NOTICE OF PUBLIC HEARING
Minor Variance

APPLICATION NO.:	A-24:206	SUBJECT PROPERTY:	47- 49 Ontario Avenue, Hamilton
ZONE:	"R1a" (Low Density Residential)	ZONING BY-LAW:	Zoning By-law No. 05-200

PROJECT NAME/ADDRESS:
49 ONTARIO AVENUE FOURPLEX

Re: APPLICABLE LAW REVIEW – ZONING BYLAW
Present Zoning: R1a (Low Density Residential – Small Lot)
Address: 47 and 49 Ontario Avenue, Hamilton

SP1.01

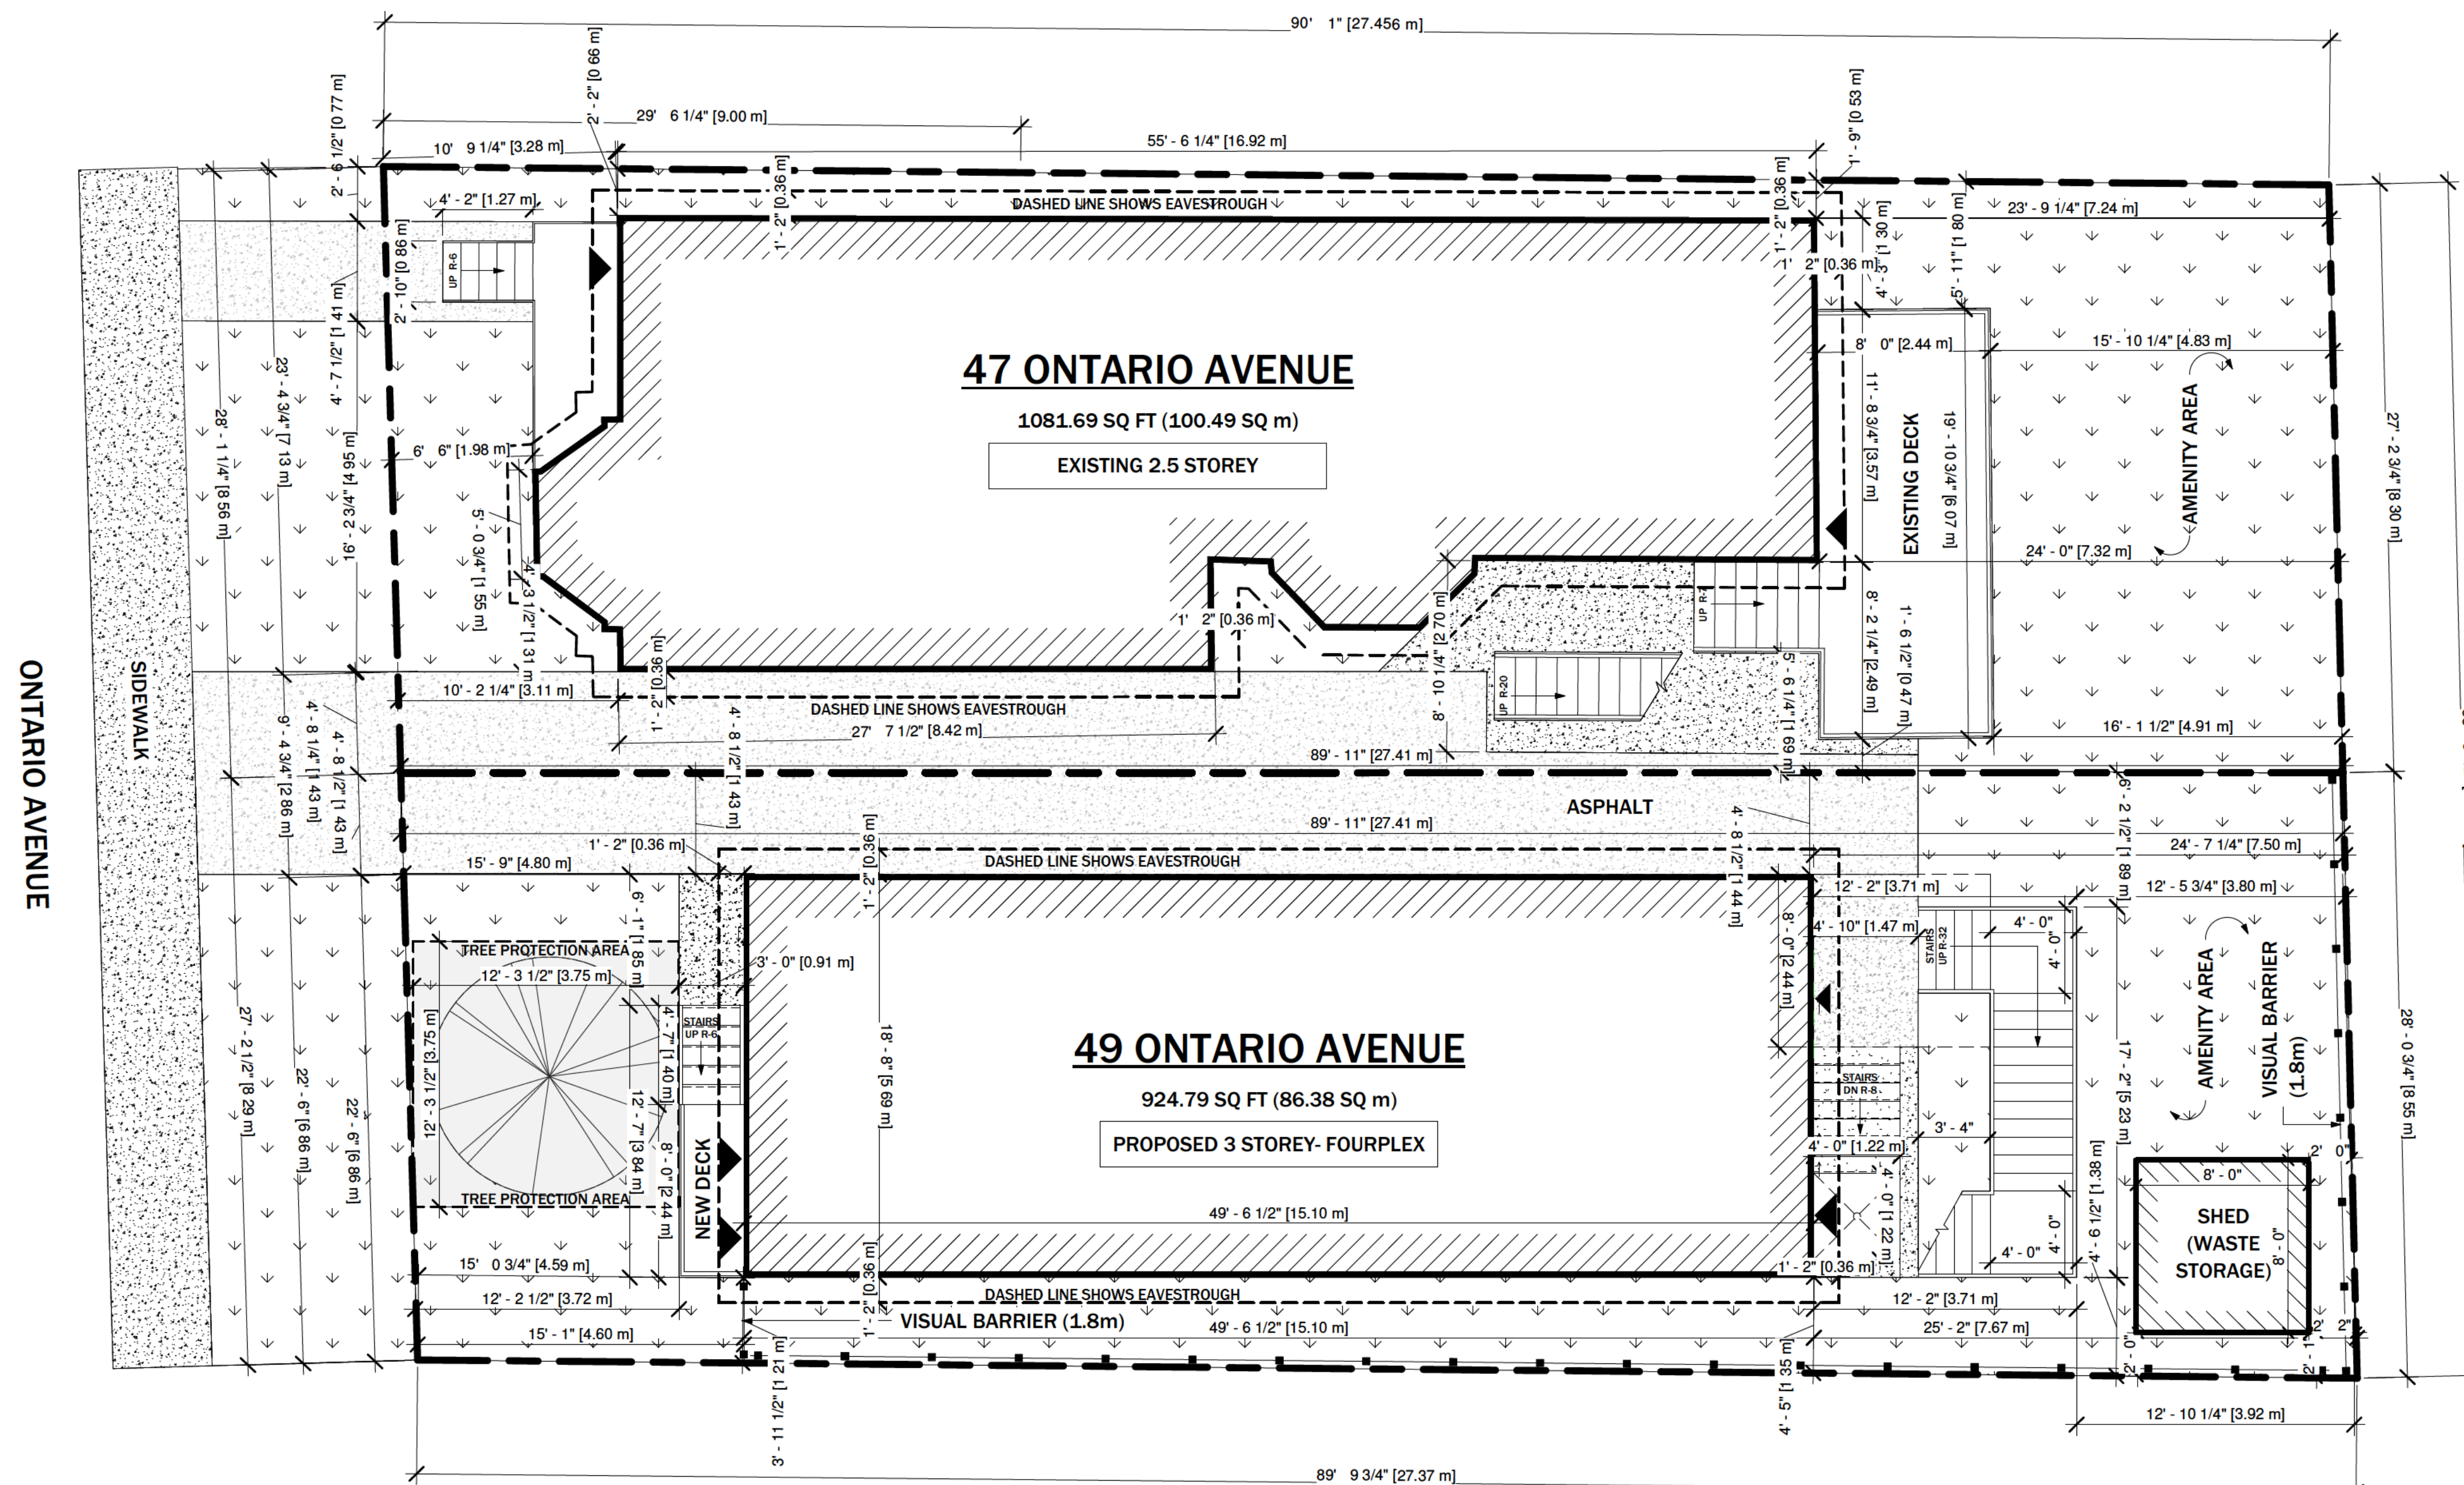
d) A porch, deck or canopy may encroach into any required yard to a maximum of 1.5 metres, or to a maximum of half the distance of the required yard, whichever is the lesser; The required side yard is 1.2m. Therefore, the ex. porch including any associated steps shall maintain a setback of 0.6m from the southerly side lot line.	A setback of 0.47m is shown from the existing deck to the southerly side lot line.	Non-conforming Variance Required

Required By By-Law	Provided	Conforming/ Non-Conforming
Low Density Residential – Small Lot (R1a) Zone			
Section 15.2.2.4 – Fourplex (Severed lands) NOT FINAL			
Minimum Lot Area [as per Section 15.2.2.4 a)] NOT FINAL	300.0 square metres	230.72m ²	Non-conforming Variance Required
Minimum Lot width [as per Section 15.2.2.4 b)] NOT FINAL	10.0 metres	8.29m	Non-conforming Variance Required
Minimum setback from a Street Line [as per Section 15.2.2.4 c)] NOT FINAL	i) 4.0 metres; ii) Notwithstanding Section 15.2.2.4 c) i), for lots identified on Figure 36 of Schedule "F" – Special Figures of this By-law, a building may be erected closer to the front lot line in accordance with the following: 1. Within 10 percent of the average setback from the front lot line or flankage lot line of the two adjacent dwellings, or in the case of a corner lot, within 10% of the	i) 4.0 m ii) not applied. Front Yard Setback 4.59m	Conforms N/A

Waste Storage [as per Section 15.2.2.4 k)] NOT FINAL	Outdoor waste storage shall be fully enclosed and shall not be located in the front yard.	<p>Details not provided.</p> <p>Waste Storage Shed added</p>	Unable to determine compliance
Section 4 – General Provisions			
Permitted Yard Encroachments [as per section 4.6 of Hamilton Zoning By-law 05-200]	a) Eaves, troughs and other similar architectural features may be permitted in any required yard, or to a maximum of half the distance of the required yard, whichever is the lesser.	<p>Details not provided.</p> <p>14" Eavestrough added</p>	Unable to determine compliance

d) A porch, deck or canopy may encroach into any required yard to a maximum of 1.5 metres, or to a maximum of half the distance of the required yard, whichever is the lesser;	A setback of 3.80m is shown from the deck and associated steps to the rear lot line.	Non-conforming Variance Required
	<p>The required rear yard is 7.5m. Therefore, the proposed porch including any associated steps shall maintain a setback of 6.0m from the rear lot line.</p> <p>The required side yard is 1.2m, a minimum aggregate of 3.5m.</p>	<p>A setback of 1.38m is shown from the southerly side lot line and a setback of 1.89m is shown from the northerly side lot line.</p> <p>A setback of 3.09m appears to be maintained from the</p>	<p>Non-conforming Variance Required</p> <p>Appears to</p>

Required By By-Law	Provided	Conforming/ Non-Conforming
Section 5 – Parking (Existing Regulations)			
Location (All Uses) [as per section 5.1(a) of Hamilton Zoning By-law 05-200]	i) Required parking facilities shall be located on the same lot as the use requiring the parking.	No parking is proposed to be maintained on the retained lands. However, records indicate that the existing dwelling was built in the year 1895 at which time there were no requirements. No parking is proposed to be maintained on the severed lands.	Conforms – Existing Non-conforming Variance Required
Minimum Number of Required Parking Spaces [as per section 5.6 c) of Hamilton Zoning By-law 05-200]	<u>Single Detached Dwelling</u> 1 parking space per unit However, our records indicate that the existing dwelling was built in the year 1895 at which time there were no requirements. <u>Multiple Dwelling Unit:</u> 1 per unit, except where a dwelling units is 50m ² of GFA or less in which case at a rate of 0.3 per unit. Please note that under the existing zoning regulations, there are no requirements for a fourplex. The use is considered a multiple dwelling with four (4) units. In addition, the GFA for each unit is unknown as such, worse case scenario has been applied. Therefore, 4 units x 1 = 4 spaces shall be maintained on the severed lands.	No parking is intended to be maintained on the retained lands. No parking is intended to be maintained on the severed lands.	Existing Non-conforming Variance Required
